# UNITED STATES PATENT AND TRADEMARK OFFICE

APPLICATION NO.	FILING DATE	FIRST NAMED INVENTOR	ATTORNEY DOCKET NO.	CONFIRMATION NO.
09/939,543	08/27/2001	Todd Schweitzer	T-3827	6768

**Office Action Summary**

## DETAILED ACTION

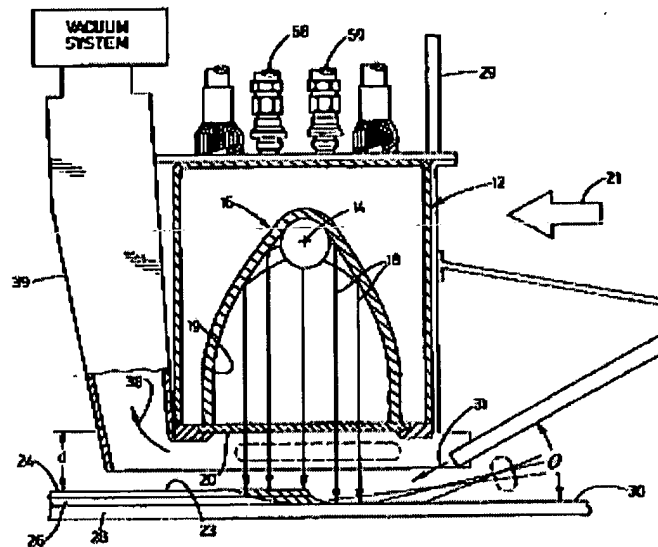
Kolb et al. disclose an irradiation apparatus comprising:

a NEMA 4 watertight housing that forms an enclosure and which has a floor in which an irradiation window opening (FIG.1, element 20 and column 9, line 49-51),

a quartz window disposed across said window opening in watertight sealed engagement therewith (FIG. 1, element 20 and column 9, line 45-48),

a energy generator (FIG. 1, element 14) positioned within said watertight housing proximate said window opening to emit energy through said quartz window to an area at the exterior of said housing beneath said quartz window (FIG. 1, element 30), and

ultraviolet radiation generator to focus ultraviolet radiation therefrom upon said quartz window (FIG. 1, element 16, 19).

an inlet duct and an outlet duct to said housing for water cooling the energy generator (FIG. 1, element 58-59).

**Referring to claims 4, 8:** wherein said floor of said watertight housing is formed of stainless steel and said watertight housing is further comprised of laterally enclosing upright stainless steel walls extending up from said floor and a stainless steel lid to which said inlet and outlet ducts are joined (FIG. 1).

Kolb et al. do not disclose that the energy generator is a microwave excited ultraviolet radiation generator includes an electrodeless lamp that produces ultraviolet radiation cooled by directing cooling air toward the electrodeless lamp and withdrawing from the housing air that has passed the electrodeless lamp.
